ADDENDUM NO. 2

SUSSEX COUNTY COURTHOUSE

JURORS ENTRANCE

**CONTRACT #: MC0201000028A**

ENCLOSURE SECTIONS &

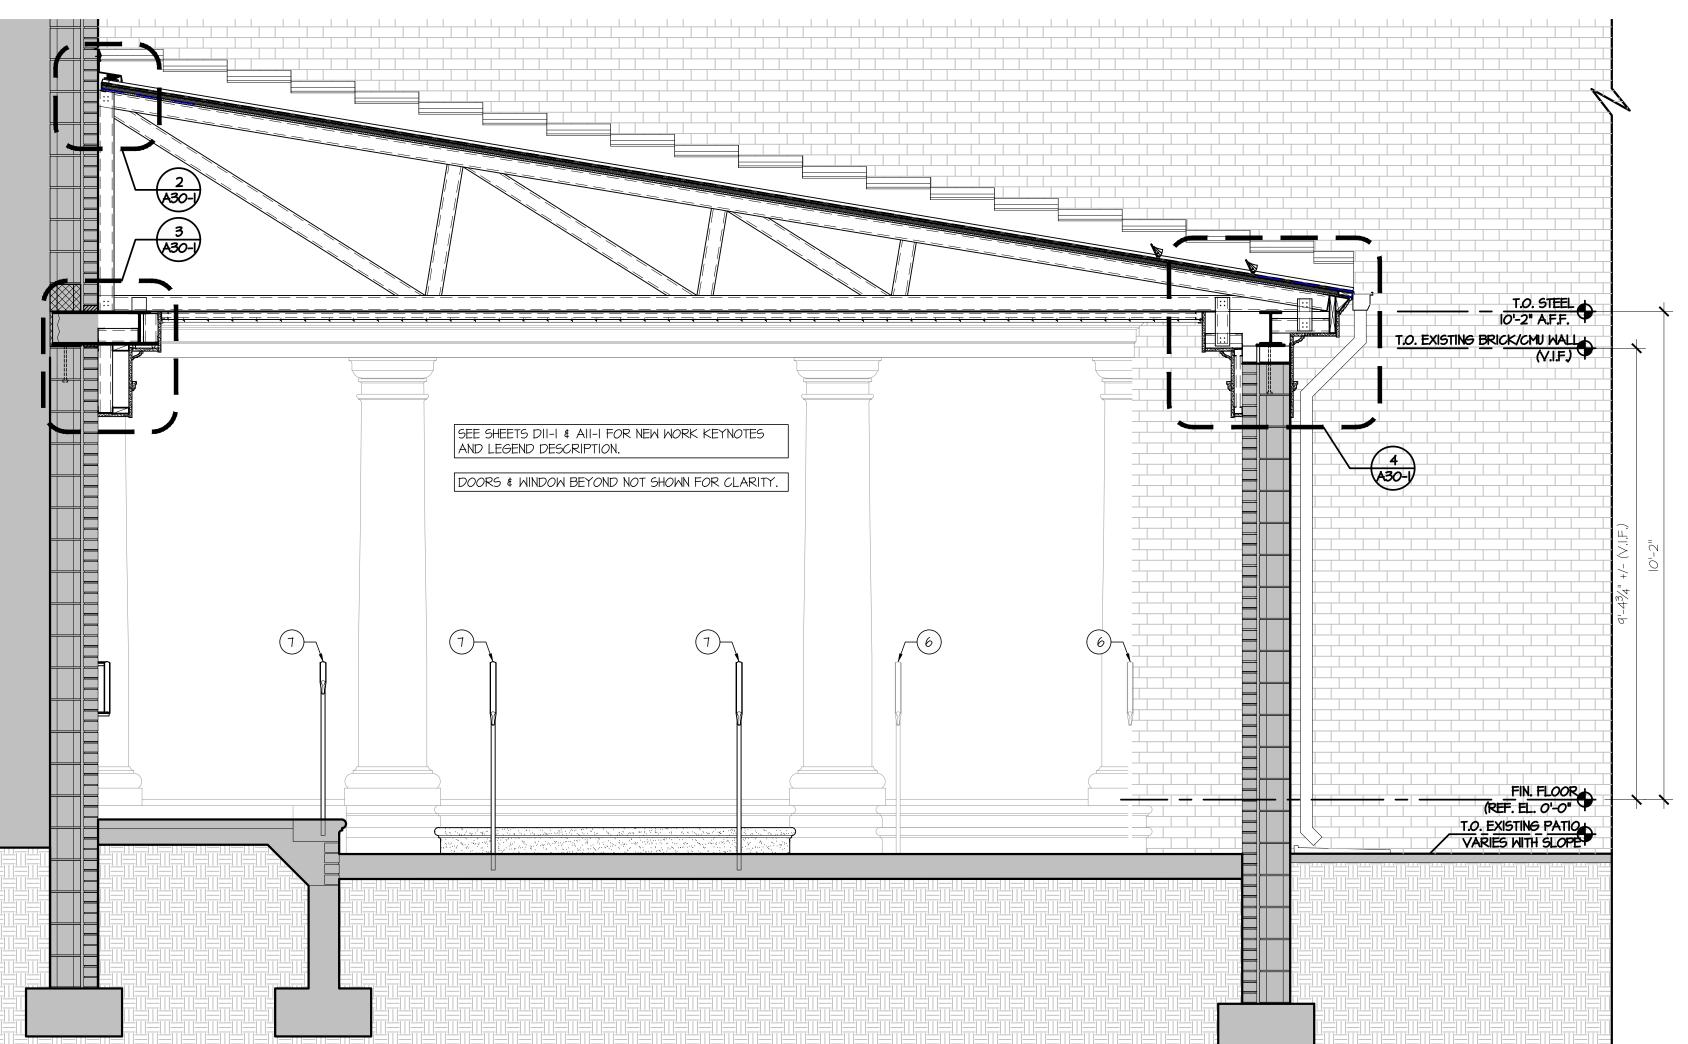
- Q4 Can drawing A30-1 sizes be provided for all molding & profile numbers?
- A.4 See updated Sheet A30-1 with profiles for Crown and Bed Mold.
- Q.5 Drawing A30-5 Detail 2 calls for nonsplit column covers, is it your intent to wrap around a steel columns. Please advise.

- Q.6 Can a sprinkler drawing be issued for pricing?
- A.6 See Sheet FP11-1 for Fire Protection Renovation Plan included in the Bid Set of Drawings.
- Q.7 Drawing A30-1 are you to assume 5/8 plywood on the truss, 1" insulation with another layer of 5/8 plywood on top of the insulation?

- A.7 Correct, See updated Sheet A30-1 with clarification of (2) layers of sheathing with 1" insulation between the layers of sheathing.

71/4" 'AZEK' (PROFILE AZM-28) 3 ½"SOLID -CELLULAR PVC BED MOLDING, PRIMED & PAINTED. 'AZEK' (PROFILE AZM-28) 3 ½" SOLID CELLULAR PVC BED MOLDING, PRIMED & PAINTED. 'AZEK' (PROFILE AZM-7954) -SOLID CELLULAR PVC, SOLID 'AZEK' (PROFILE AZM-7954) CROWN, PRIMED & PAINTED. SOLID CELLULAR PVC, SOLID CROWN, PRIMED & PAINTED. BOARD. PRIMED & PAINTED.
